2024.00373.000

George Hotel
Refurbishment (Planning & LBC)
Response – Cycle Storage

(File Ref: 2025_4891147_W - 15 - Response - Cycle Storage_29.08.25)

August 2025

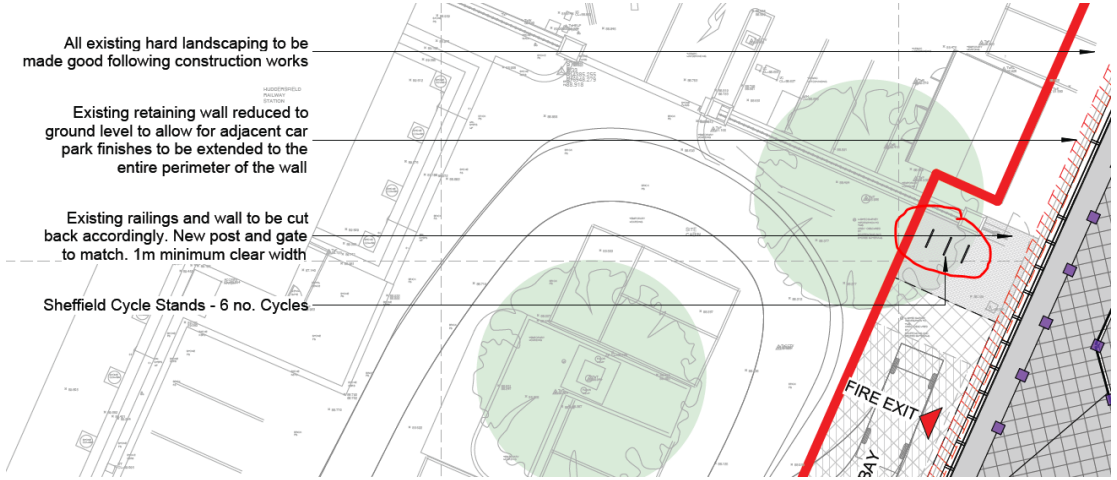
The Lead planning officer Jillian Rann raised a concern that the previous application 2023/48/90024W, a condition was placed on the approval by request of the relevant elected member relating to the provision of cycle storage within the development and that this provision is likely to be required under the revised/ new application this report pertains to:

The applicant, agent and lead architect have been attending fortnightly meetings with the LPO and conservation officers and in meeting on 26July 2025 this matter was raised over concerns that the current application did not appear to allow for the provision of cycle storage.

On 02.07.25 AHR submitted additional information namely the site plan below which indicated the provision of 3nr Sheffield stand hoops to the side entrance/ railway station elevation (for 6nr cycles):

The applicant supplied this information with an explanation that the provision of cycle storage internally is extremely problematic from a fire compliance perspective due to recent concerns around electric cycles and lithium battery fires which could not reasonably be mitigated.
